Project Our Town Hall

Drg Title Landscape General Arrangement

Drg No.	Suitability	Revision
OTH-PLA-EE-ES-DWG-L-1000	S4	C02

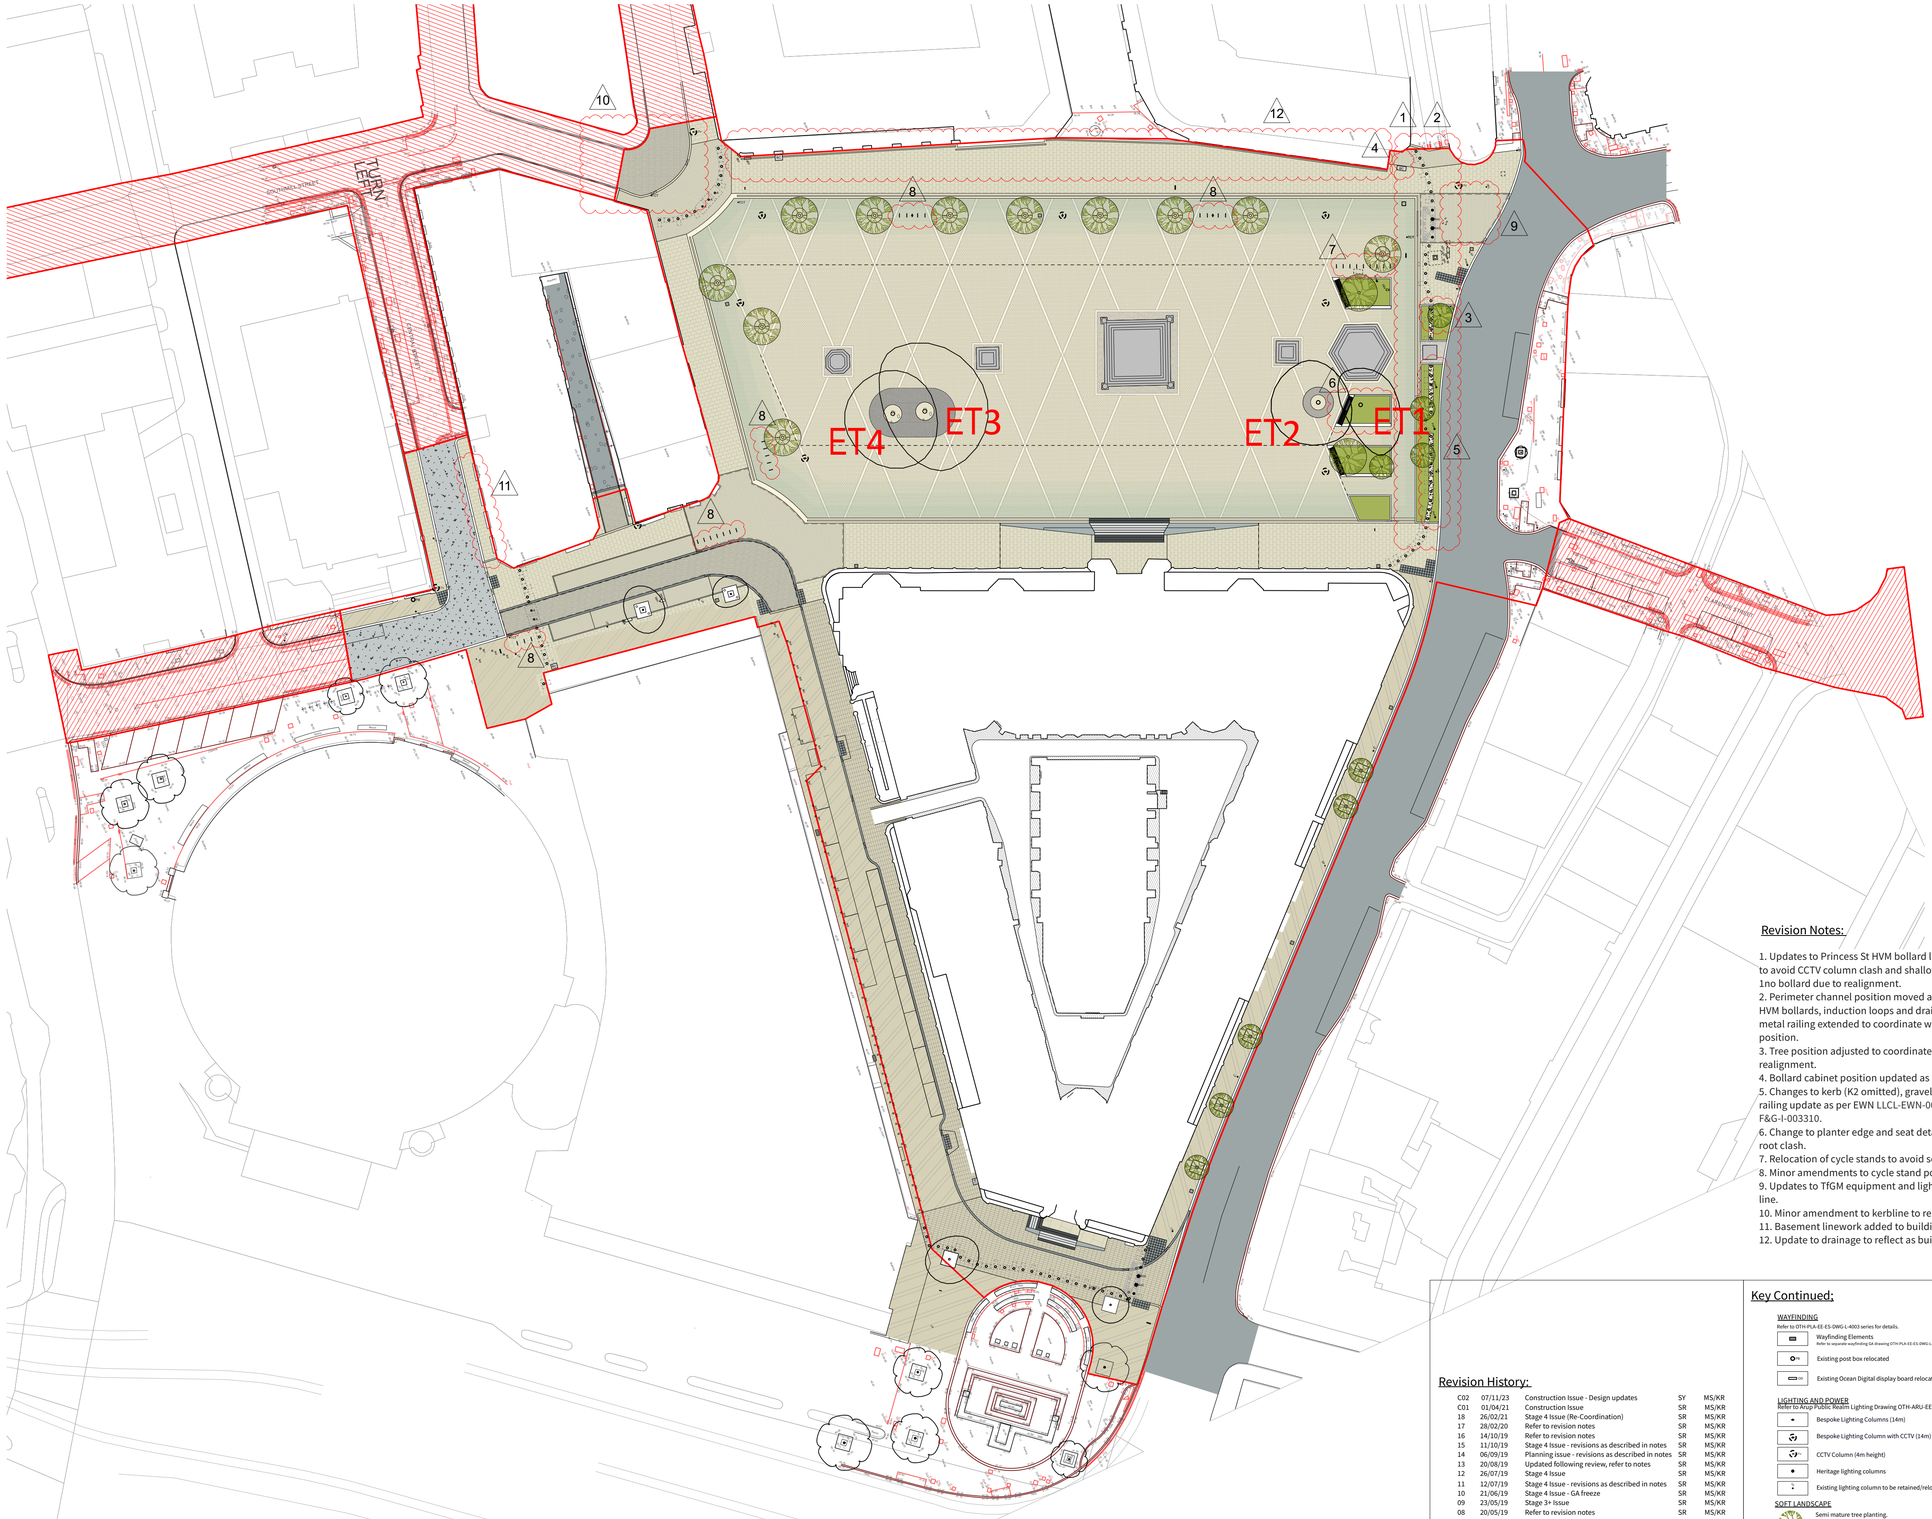
1. Updates to Princess St HVM bollard line - positions adjusted to avoid CCTV column clash and shallow services. Omission of 1no bollard due to realignment.

2. Perimeter channel position moved as part of coordination of HVM bollards, induction loops and drainage. Planters and metal railing extended to coordinate with new channel position.

3. Tree position adjusted to coordinate with bollard realignment.
4. Bollard cabinet position updated as agreed with LPA.
5. Changes to kerb (K2 omitted), gravel margin added and railing update as per EWN LLCL-EWN-001929 and Instruction F&G-I-003310.

6. Change to planter edge and seat detail to avoid existing tree root clash.
7. Relocation of cycle stands to avoid service cover clash.
8. Minor amendments to cycle stand positions / spacing.

9. Updates to TfGM equipment and lighting etc around HVM line.
10. Minor amendment to kerbline to reflect as built position.
11. Basement linework added to building edge on Central St.

12. Update to drainage to reflect as built.
